Application No. SDP15-00002 (Site Development Permit) and Administrative Adjustment of Standards

Staff Report

- Applications: Project No. PRJ12-00009
Site Development Permit: SDP13-00005
- Project name: Issaquah Gateway Apartments
- Staff Contact: Amy Tarce, Senior Planner
Development Services Department. 425-837-3097
amyt@issaquahwa.gov

Figure 4. Primary Through Block Passages (arrows) transect the large blocks and provide significant pedestrian routes, creating a finer grid of Circulation Facilities.

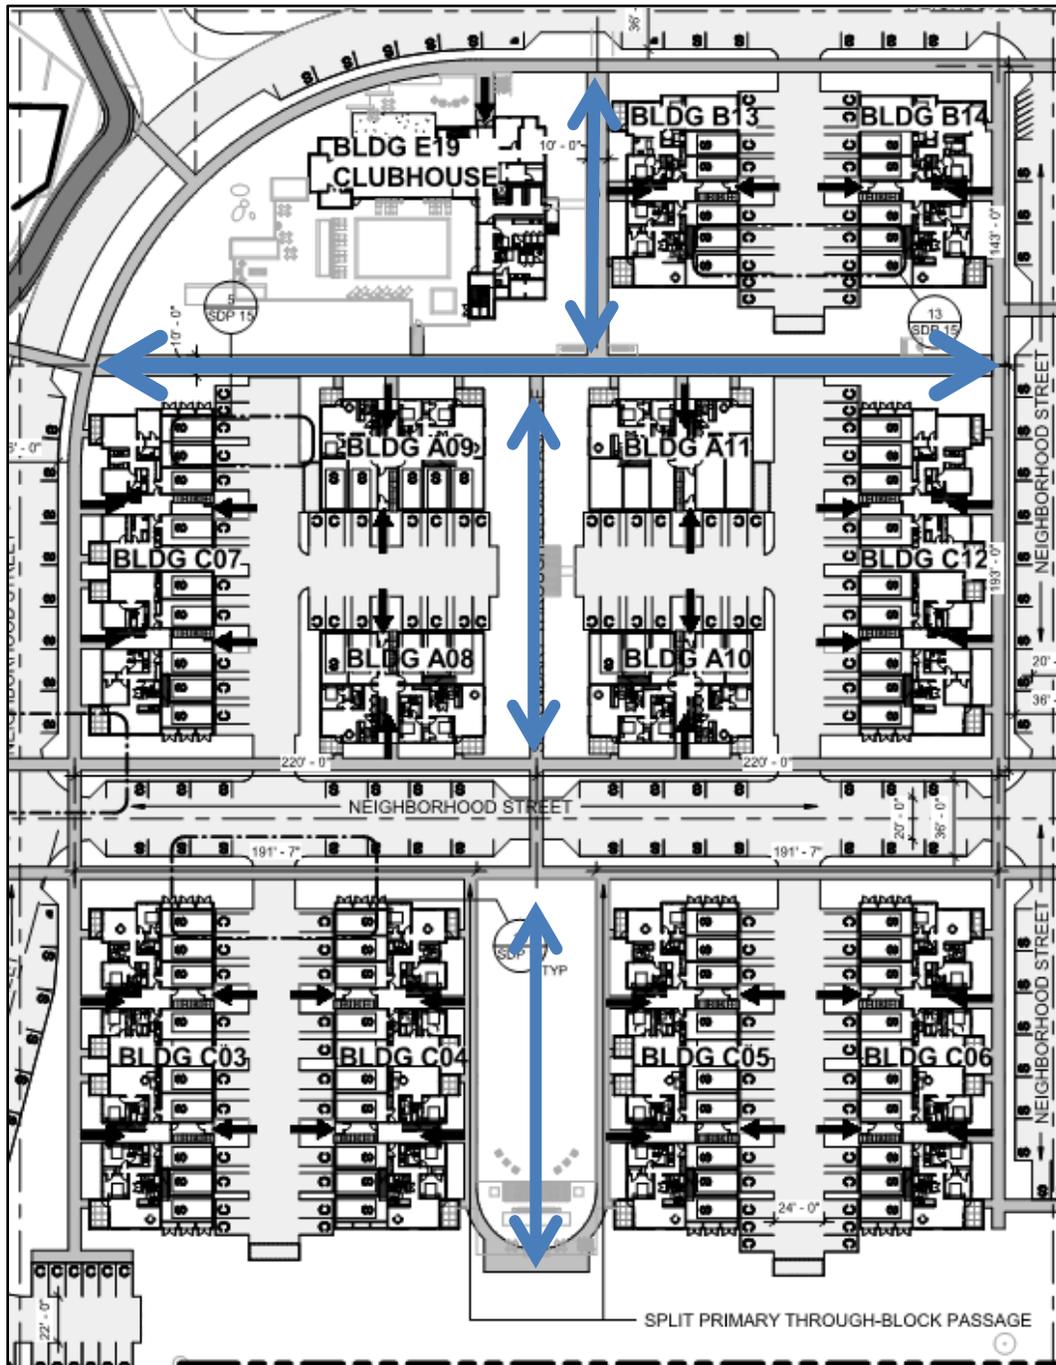
The Primary Through Block Passages serve multiple purposes, including providing a circulation facility on which some buildings front if they do not face a street, breaking up the large neighborhood blocks into walkable lengths, providing major pedestrian linkages to the various community spaces on site, and creating additional open spaces between the residential buildings. These routes comply with the standards, proposing a corridor width of 20 feet and a walkway of 10 feet with landscaping and lighting (see sheet SDP 02 for street classification and sections). Apartments that will front these passages are proposed to have private fenced patios to establish the boundary between public and semi-private spaces along the Through Block Passage. The fences are not primarily for security.

[Condition 8] The fencing for residential patios fronting Primary Through Block Passages shall be limited to a maximum height of 3 feet.

Figure 6. A 10-foot wide sidewalk (dash line) will be required for the eastern side of the Neighborhood Street in lieu of two 6-foot wide sidewalks on both sides of the street.

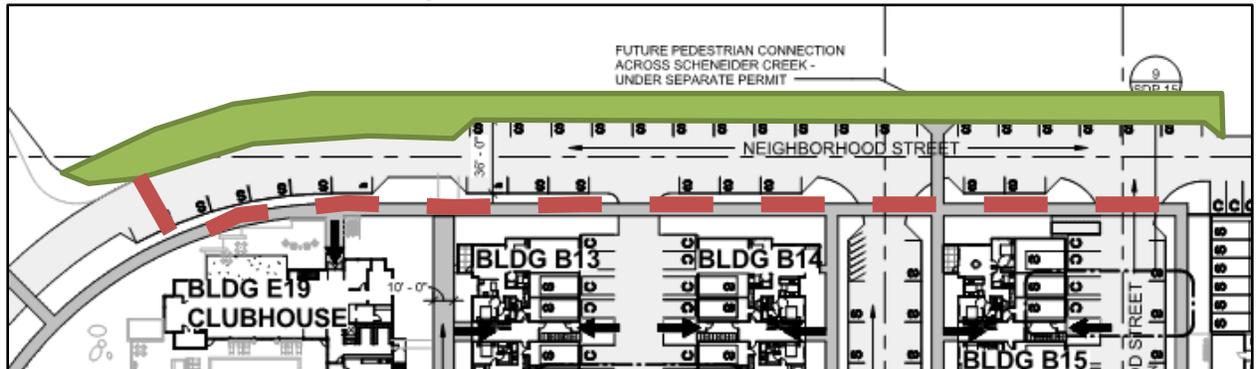
Neighborhood Street standards for the street at the western end of the site that abuts the WSDOT conservation area (access drive) and the Schneider Creek buffer. No sidewalks and street trees are provided on the western side of the street (See Figure 5).

C. Figure 5. The Neighborhood Street that runs along the western edge of the property is missing street trees and sidewalks along the western half of the street.

In lieu of sidewalks at the west side of the Neighborhood Street, the applicant will be required to provide a 10-to-12 foot wide sidewalk along the east side of the Neighborhood Street, where more pedestrian traffic is encouraged. The parallel parking width will be reduced to 7 feet, from 8 feet. For the access drive from Newport Way, the applicant will adjust the road’s arc to accommodate the 6-foot sidewalk on the west side of the street. At the intersection of the access drive and the curved section of the Neighborhood Street, the Shared Use Route hugs the travel lanes and the street trees and planter strip is missing. The Applicant will be required to put in street trees and a planter strip at this pinch point along the Shared Use Route. The Director has determined that this deviation from the Neighborhood Street standards meets the criteria for an AAS with conditions:

[Condition 9] *Plant trees on the western side of the Neighborhood Street in the Schneider Creek buffer area and adjacent to the WSDOT conservation area at a consistent alignment and distance to match the street trees on the opposite side of the street.*

[Condition 10] *Provide a minimum 10 foot wide sidewalk at the eastern side of the Neighborhood Street serving the buildings 13, 14 and 15, and the community center. Design the patios and side façade of the ground floor residential units of buildings 13, 14, and 15 to engage the Circulation Facility that intersects the one where the building entrances face. (Apply CIDDS 11.3.H, 14.4.A.7, 14.2.B, 16.3.E)*

Figure 8. Modified Primary Through Block Passage at Central Greenspace

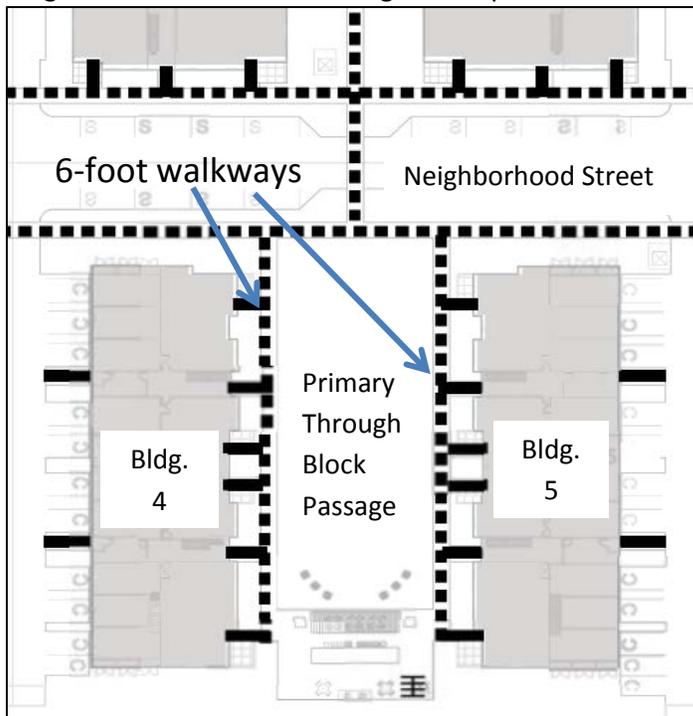
- E. Walkway Width of Primary Through Block Passage serving Building 4 and Building 5
CIDDs 14.4.A.5 requires primary building entrances to be accessible and visible from Circulation Facilities. A related standard in Sec. 11.3.M, Residential Front Door Orientation, specifically requires the principal façade to be oriented to a street or a street-facing courtyard. Buildings 4 and 5 have their principal façade oriented to a courtyard. To comply with Sec. 14.4.A.5, a modified Primary Through Block Passage is provided. Instead of a 10-foot wide paved walkway, two 6-foot wide walkways are provided (see Sheet L1.14). The walkways connect to the sidewalk of the Neighborhood Street at a 90-degree and provide a direct route to the entrances of Buildings 4 and 5.

The Director found that the adjustment of standards for the Primary Through Block Passage serving Building 4 and Building 5 meets the approval criteria for an AAS:

Figure 12. A 10-foot bike/pedestrian connection should be provided on Newport Way

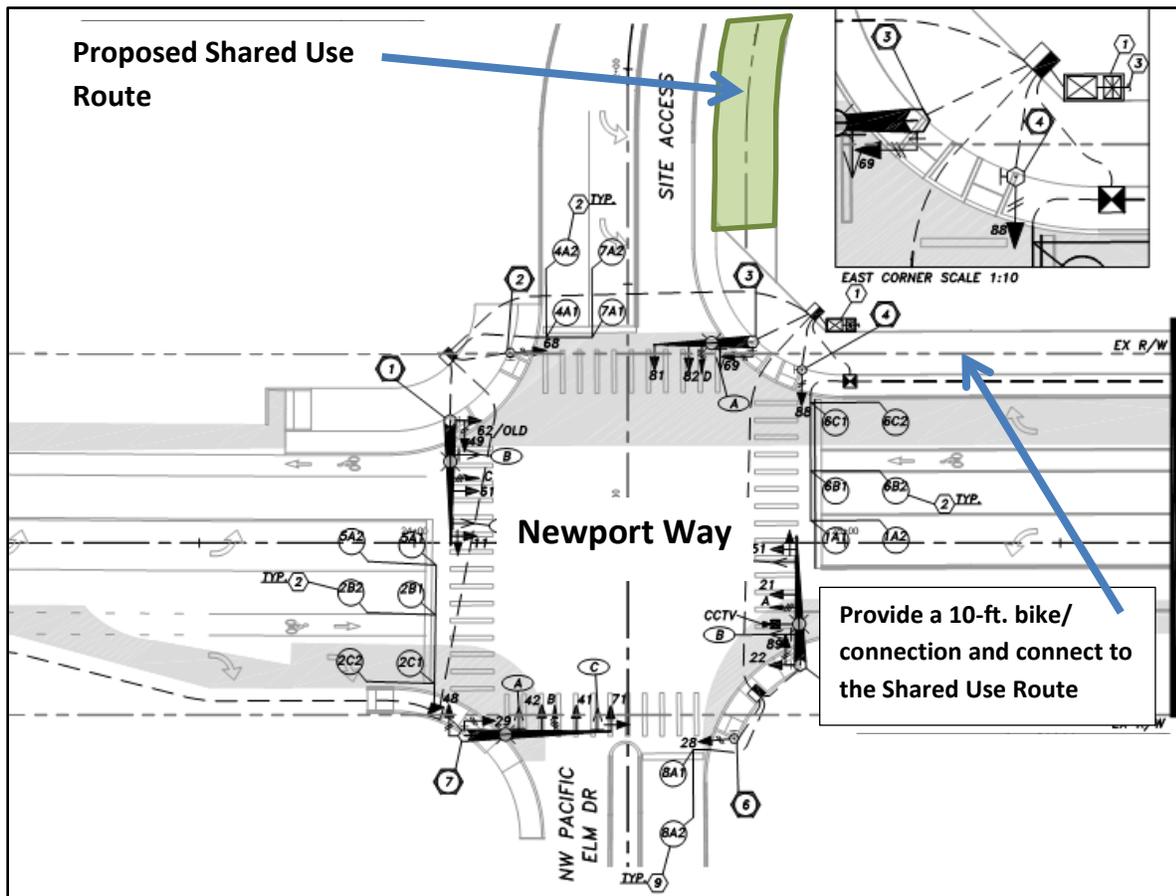
The Neighborhood Park is connected to the natural buffer areas of Tibbetts Creek and Schneider Creek through the network of sidewalks, Through Block Passages and the Shared Use Route that serve the site. Visual cues, such as the 10-foot wide sidewalk/bike connections, park furniture and signage visible from Newport Way, can help the public and the community-at-large know that there are other sections of the park in the interior of the site. Access to nature is not only through the landscaped open spaces in the project. Visual access to hillsides and the Issaquah Alps from the open spaces within the site are also provided.

[Condition 39] Provide a 10-foot wide pedestrian/bike connection along the Newport Way frontage to the sidewalk of the loop road to connect the proposed Neighborhood Park to the existing King County trail east of the project site and the Mountains-to-Sound Greenway

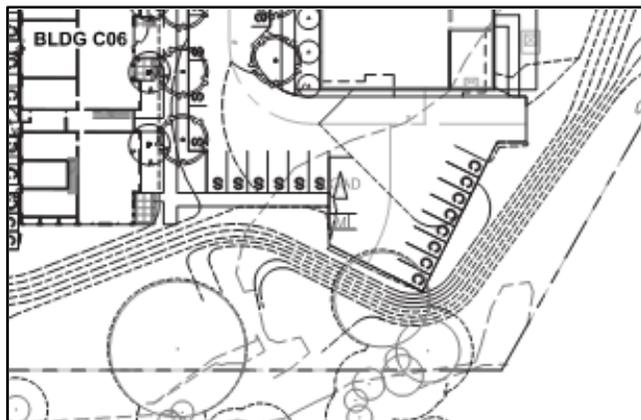
At the northeast corner of the property, across from Building 6, there appears to be an excessive amount of pavement for the surface parking lot. The landscape plan, (sheet L1.01), shows this area without any parking lot trees or landscape islands.

Where the short end of the parking area abuts a Circulation Facility, these areas will be required to be screened with vegetation and ornamental fences. [Conditions 45] *Where parking areas abut pedestrian circulation or areas, such as the Shared Use Route, Through Block Passages and the termini of the parking area drive aisles at the 3-story buildings, edge landscape at least 3 feet deep or alternative, measured from the curb, shall be provided.*

Figure 21. Parking areas abut Through Block Passages

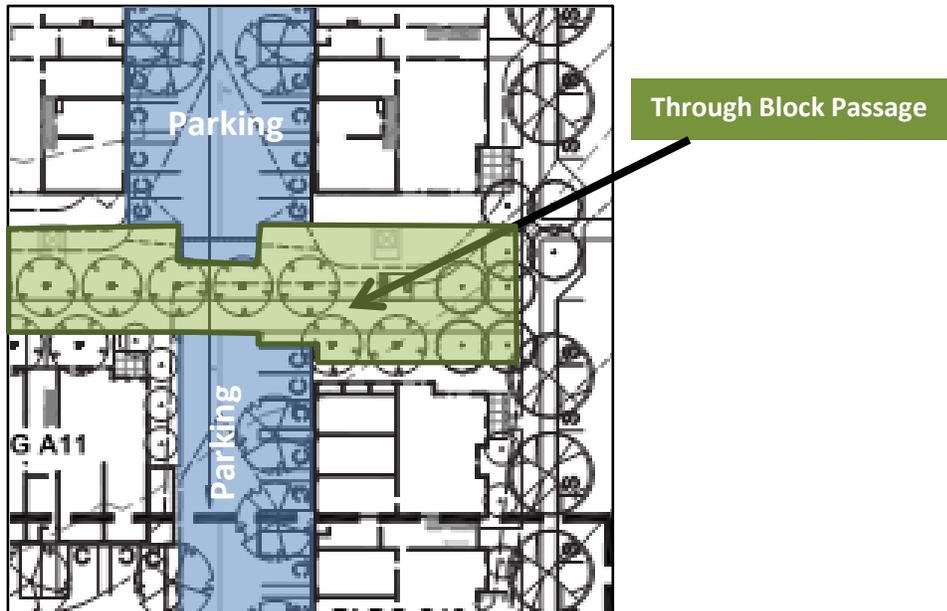
Edge landscaping is required when parking lots abut public rights-of-way, Community Spaces, or Circulation Facilities. Edge landscaping, as prescribed, has a minimum width of 3 feet or substituted with fencing or a wall that is at least 75% opaque. Edge landscaping appears to be missing in many areas where a parking area abuts a Through Block Passage. However, it may be that the Applicant has not fully developed the landscape plan to this level of detail since sheets L1.03 to L1.05 show greater level of details for focused areas that are not shown on the Overall Landscape Plan.

[Condition 53] Where parking areas abut pedestrian circulation or areas, such as the Shared Use Route, Through Block Passages and the termini of the parking area drive aisles at the 3-story buildings, edge landscape at least 3 feet deep or alternative, measured from the curb, shall be provided.

Figure 22. Parking areas visible from the Shared Use Route and Neighborhood Park

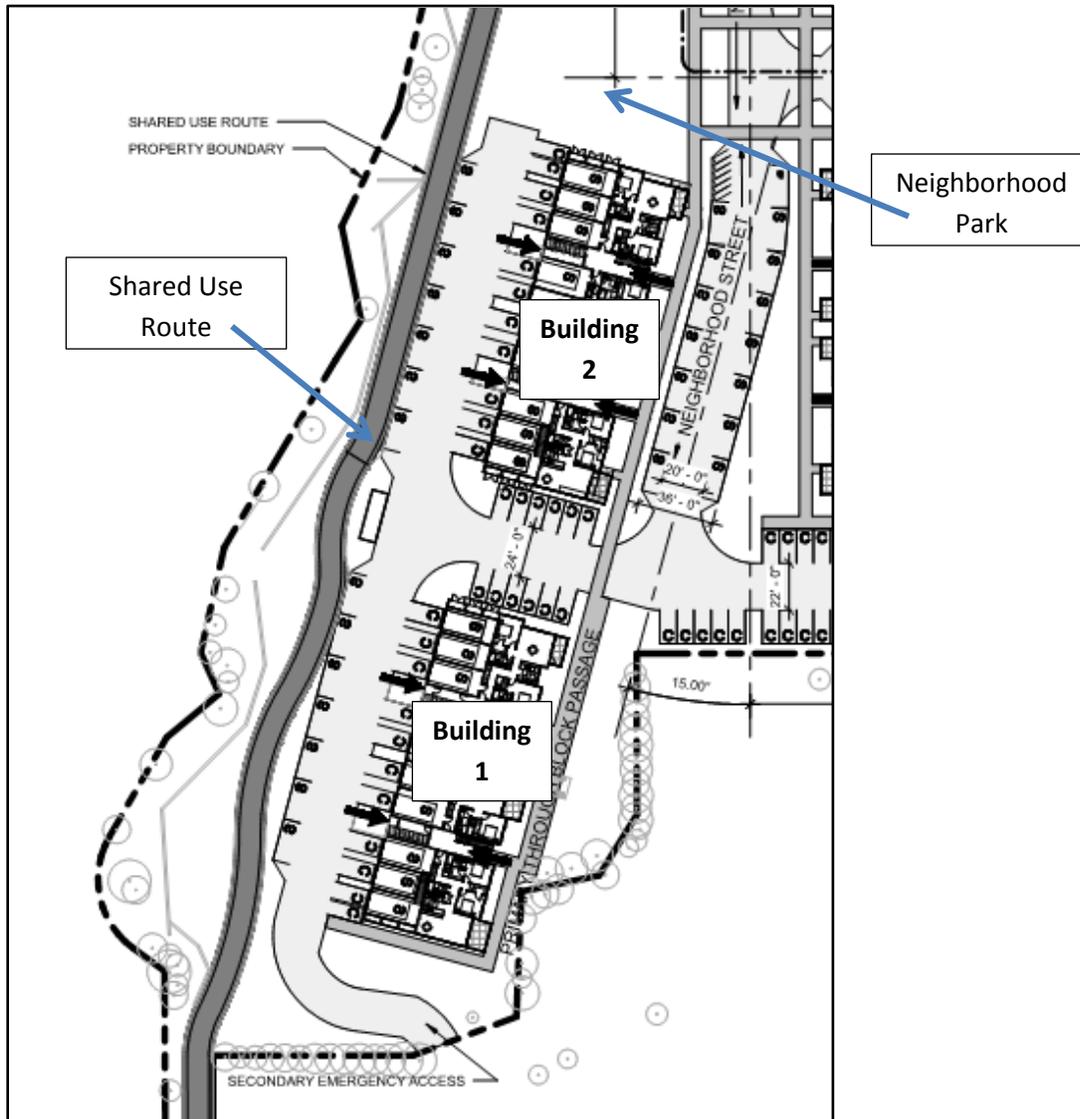
Another area where edge landscaping would be critical is along the Shared Use Route and the Neighborhood Park. The parking area for Building 2 is visible from two public spaces: the Shared Use Route and the Neighborhood Park (see Fig. 22). The parking area for buildings 1 and 2 are entirely visible from the Shared Use Route. Moreover, the Shared Use Route is tucked between the Sammamish Condominiums, retaining walls, and the parking area for the entire length of buildings 1 and 2. Additional clearance is required for the parallel parking as a Shared Use Route only requires 2 ft of landscape along the edge. Locating the parallel spaces next to the Shared Use Route is not safe without additional separation because the car doors will open unto the travel path of pedestrians and bicyclists. There should also be a clear transition between the Shared Use Route as a public facility and the parallel parking spaces that are meant to serve only the residents of the Gateway Apartments.

[Condition 54] Provide at least a 4 feet wide landscape buffer between the parallel parking behind buildings 1 and 2 and the shared use route. Plant material used should be able to survive the high pedestrian traffic and of a height to allow car doors to open into the landscape area without damaging the plants (condition 16.2.L)

Figure 28. Detail plan of the clubhouse showing its relative location to the maximum Build-to-Line (dash line) and outdoor seating visible from the street.

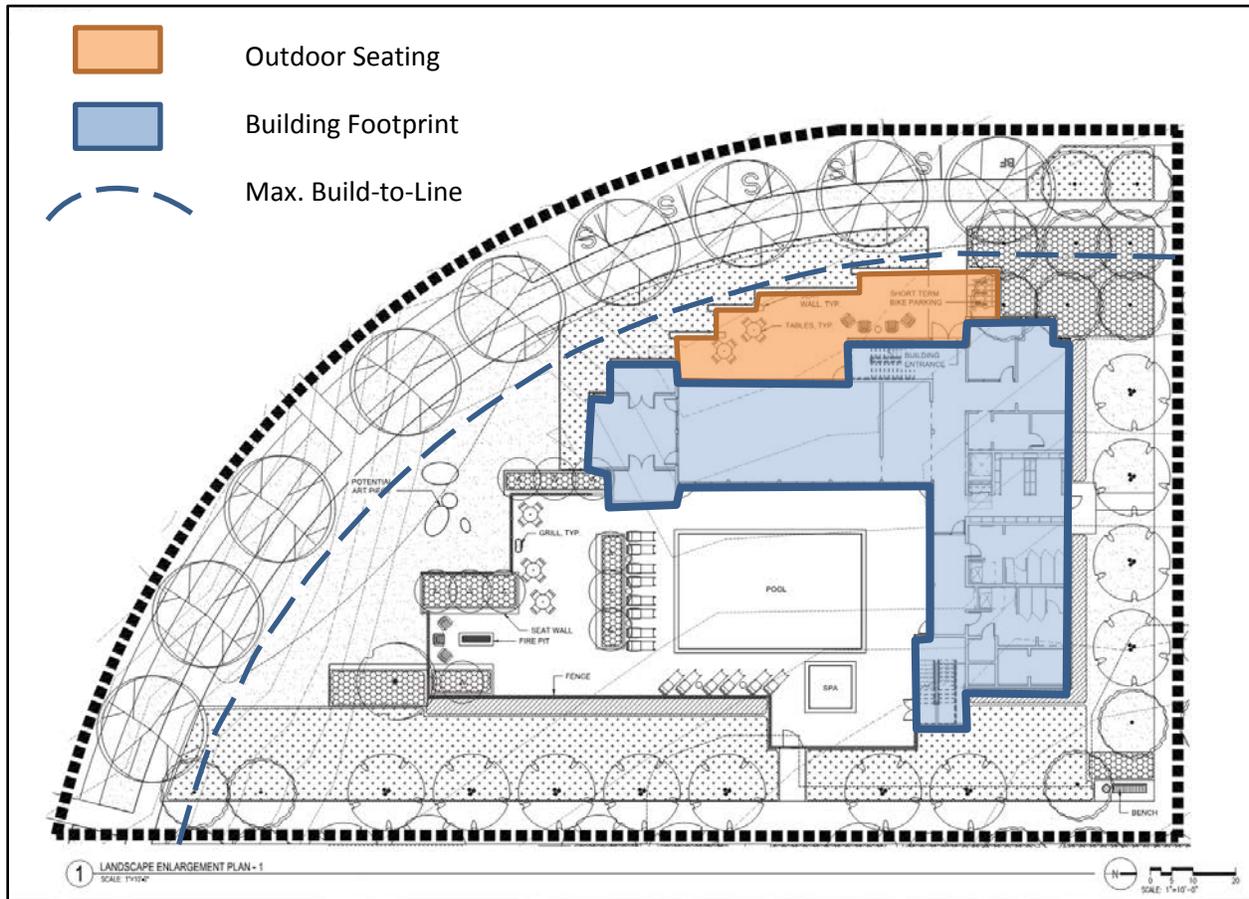
No streetwall is provided at the Newport Way frontage of the property (see sheet L1.18, Schematic Plan Phase 1 of the Neighborhood Park). The full length of the residential buildings sits at the “Build-to-Line” zone, within the allowed 0 to 15 feet, measured from the back of the sidewalk (see sheet SDP 02 for dimensions). The 3-story buildings are located between 5 feet to 10 feet of the back of the sidewalk. The 5-story buildings sit 11 feet from the back of the sidewalks. The community center, however, is recessed beyond the 15 feet maximum “Build-to-Line” and will need to be adjusted. Given the curved configuration of the area where the community center is located, the building was designed to follow the curvature of the street. The shortest distance between the sidewalk and the building face, at the building entry, is approximately 20 feet (please see sheet SDP 02 for site dimensions). In the VR, Village Residential Zone, the required minimum length of the building that should sit on the Build-to-Line is 60%. The community center is designed with most of its street frontage consisting of an outdoor terrace with a low masonry wall and landscaping. It is not clear how the building meets the minimum 60% street frontage requirement. A portion of the outdoor terrace may count towards the 20% building frontage and 10% for a community space such as the outdoor dining area shown.

[Condition 69] The clubhouse or community center building shall meet the streetwall provisions for the Village Residential zone.

Figure 33B. Residential units facing parking areas will have views of trees. End units will be provided with windows to provide views of green spaces.

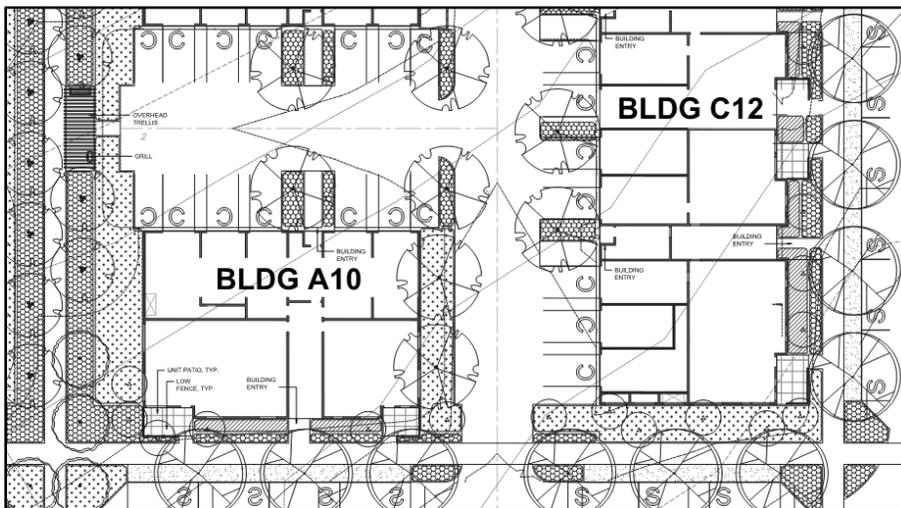
Most of the residential units have views of streets or community open spaces (see sheet SDP 02) However, the middle units of Building 3, 4, 5 and 6 have living spaces that look out to other residential units and the garages on the ground level. The distance from building face to building face between opposite units is 56 to 58 feet (see sheet SDP 02). This separation is adequate to provide privacy for units facing each other. The garages are provided with trellis elements to screen the views of the parking and drive aisles, from the residential units above the ground level (see elevation drawings, SDP 11 to SDP13. Note that the floor plans and site plans do not show the trellises but the applicant has indicated that horizontal screening elements in the parking areas will be provided.) Windows along the sides of the buildings will also afford views of green spaces for the end units (See Figure 33A, Typical Floor Plan above the ground floor).

[Condition 77] Rear building units shall be provided with visual relief from the parking areas through horizontal screening elements. End units shall be provided with windows on the sides abutting green spaces.

Figure 35A. Façade of 5-story buildings facing the I-90 Freeway

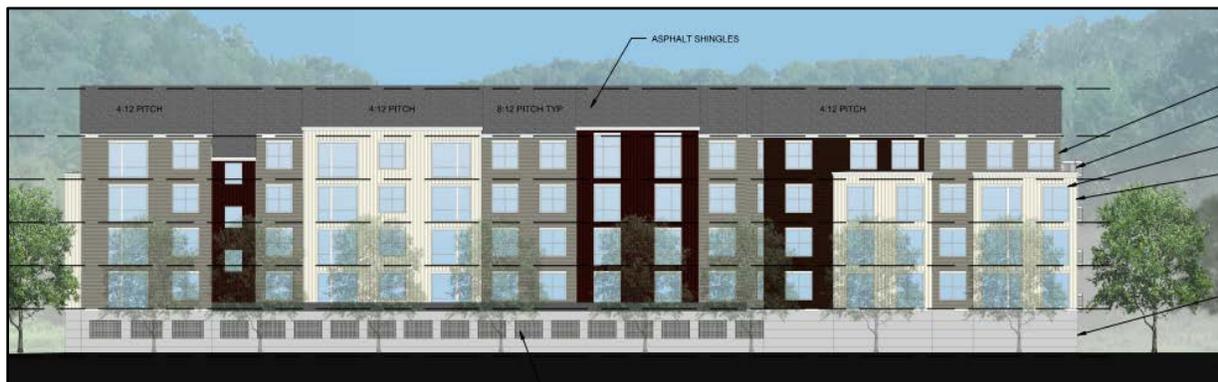
The façade of the 5-story buildings facing the I-90 freeway also do not show a strong tripartite articulation (see Figure 35A). However, the façade facing the Neighborhood Street shows a change of building materials and modulation, especially at the Neighborhood Street façade (see Figure 35B). Modulation occurs both vertically and horizontally with the receding top floor and the extended bay for the entry.

[Condition 78] The five-story buildings shall be further refined during construction permit review to employ a tripartite articulation of the façade.

Figure 37. Example of a more urban “berm” for the 5-story buildings made of planters and seating incorporated into the low wall.

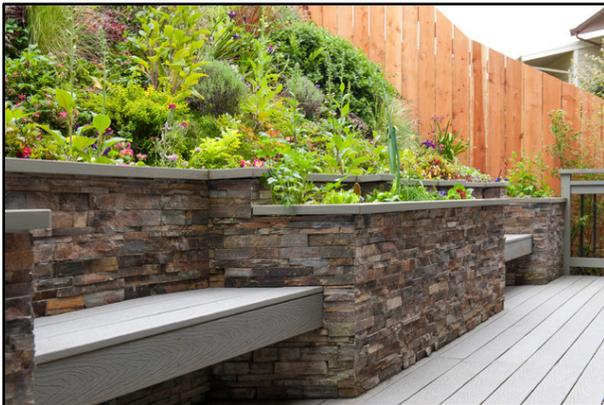
The 5-story buildings have only one entrance and the berm that serves as the base of the building does not encourage active uses at the ground level (see Figure __. Façade of 5-story buildings facing the Neighborhood Streets). The only section that is activated is at an entry plaza, provided with a bench and a planter. (Note: The elevation drawing on Sheet SDP 14, drawing 4, Bldg. D – West inaccurately shows a berm at this southwest corner of the building. The site plan shows a row of parking abutting this wall of the building, with no landscape area separating the parking from the building wall.) The length of the building facades warrants additional entries to activate the street. There are 4 balconies provided at the first level units (see sheet SDP 08, floor plan for Typical Building Type D.) The residential units are

[Condition 86] Activate the ground floors of the 5-story buildings by adding low seat walls integrated into the berms and expanding the plaza area to provide additional gathering spaces for residents. See Figure 37 in the staff report for an example of an integrated seating in a berm.
